SERVICE BULLETIN

SUBJECT 1987 AMC Renault Alliance & Encore

No. AS 1097
DATE 6/1/87
FILE IN Bulletin
Binder

"EASY ENTRY"
321632

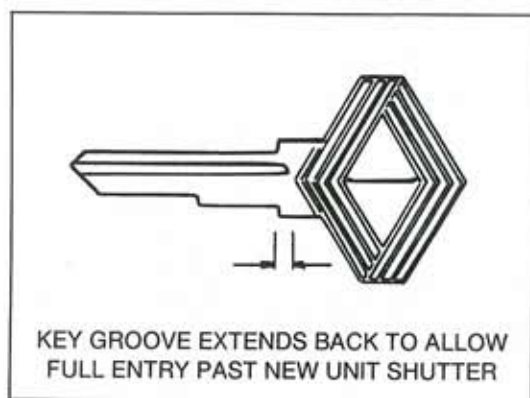
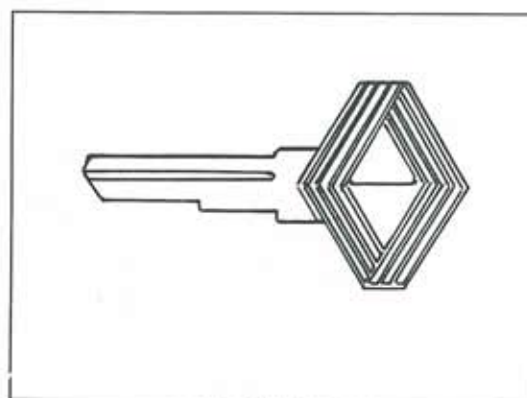
For 1987 a design change was made in the Door and Rear Compartment locks on the subject vehicles.

The changes called Easy Entry resulted in new Unit Shutters - Cylinders and Cases.

The Unit Shutter assembly now contains a Keyway Tab! As a result of added Tab, the 321256 Key Blank will not fit 1987 vehicles produced after February 15th, 1987, because of the short key groove milling.

- Key change also incorporates new tip for easier entry
- Cylinder change made to guide key into lock
- Shutter and cylinder cap both change

The new 1987 Key Blank number is: 321632
